Interactive comment on “The physics behind Van der Burgh’s empirical equation, providing a new predictive equation for salinity intrusion in estuaries” by Zhilin Zhang and Hubert H. G. Savenije

Zhilin Zhang and Hubert H. G. Savenije

Received and published: 12 April 2017

Fig. 1. Figure 5

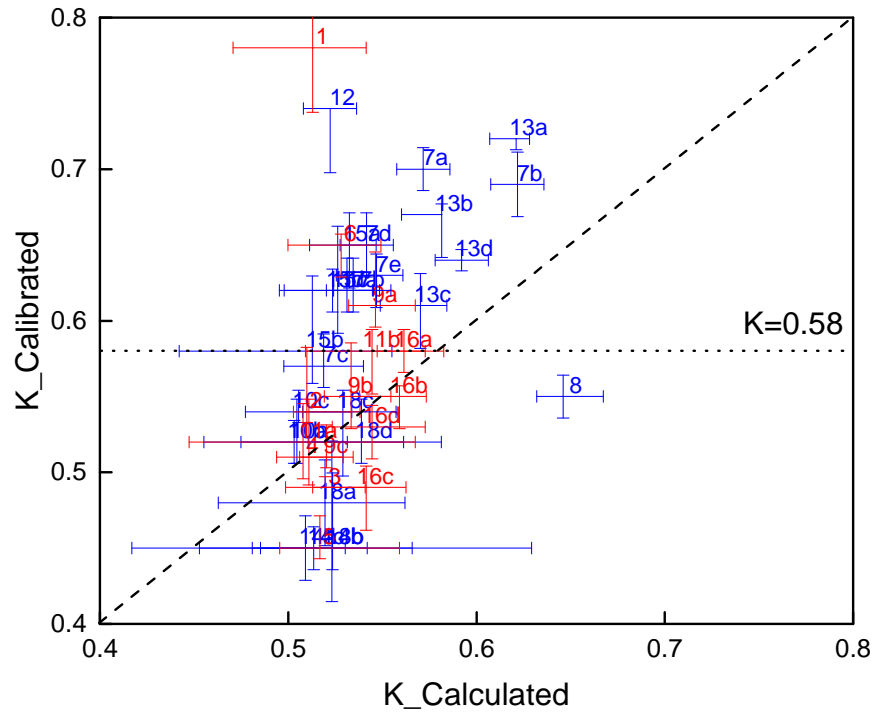
2. We have redrawn Figure 5 taking into account 25 % sensitivity of fresh water discharge (x-err) and calibration errors (y-err).

After inclusion of these uncertainty bounds, we can still see that the predictive method overestimates the low calibrated K values, and underestimates the high values. Or, that the range of (1/2, 2/3) appears too narrow. The reasons are that the predictive method does not consider the tide-driven mixing (which draws the predicted K-value further down) and that for high K-values the 2-D vertical theoretical approach underestimates lateral density driven mixing (which would increase the high values), as discussed in the reply to reviewer #1. So in estuaries with a low predicted K-value (which do not have much stratification) the K value should be even smaller as a result of tidal mixing; in estuaries with a high predicted K-value (which do have substantial stratification) the K value should be even larger due to complex 3-D density-driven circulation. In the central reach, the prediction by MacCready's equation is not bad.

In addition, there are some outliers. The outliers in estuaries #1 and #12 (Kurau and Lalang), which have very high calibrated K values, density effects may be so strong that they cause three-dimensional gravitational circulation, or the fresh water discharge may have been substantially underestimated. On the other hand in the Thames estuary (#8) tide-driven dispersion, such as tidal trapping, may have considerable influence.
